**MEMORANDUM**

RE: Fox Glen Subdivision Wetland and Stormwater Review (RZ#10-04)

Wetland 2 ponded area and woodland buffer, facing north.

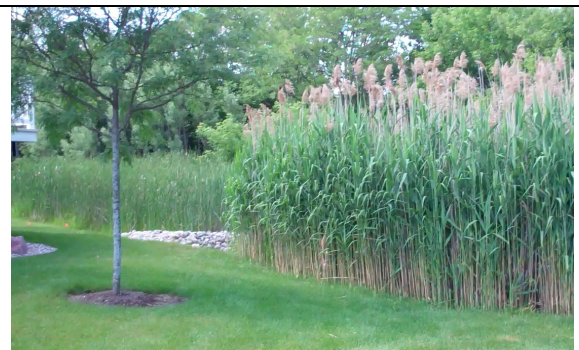
**Wetland 2** is the larger of two wetlands on the property. It is a wetland complex with a ponded portion and a mainly forested portion. Dominant vegetation is similar to that of Wetland 1 with the addition of rushes (*Juncus spp.*), duckweed (*Lemna minor*), and algae found in the open water (ponded) area. Drainage (dashed white line in Figure 1) continues through Wetland 2 and leaves the Fox Glen subdivision and enters a county drain culvert running under Ellsworth Road. ECT believes this wetland offers valuable ecological services including urban heat island mitigation, wildlife (especially songbird) habitat, nutrient and sediment removal, and stormwater storage. Given the wetland's attributes, ECT does not recommend any more vegetation trimming than what is necessary to keep sidewalks clear.

**Wetlands 1 & 2** are regulated by the Township and the Michigan Department of Environmental Quality (MDEQ). ECT does not recommend any cutting of vegetation within wetland boundaries. If stormwater outlets in the wetlands are blocked (ECT does not at this time believe they are), removal of enough vegetation to clear the blockage would be reasonable. Removal of vegetation would require a Wetland Use Permit from the Township. No disturbance of the soil appears to be warranted and is not recommended. Soil disturbance in a regulated wetland would require a permit from the Township and the MDEQ.
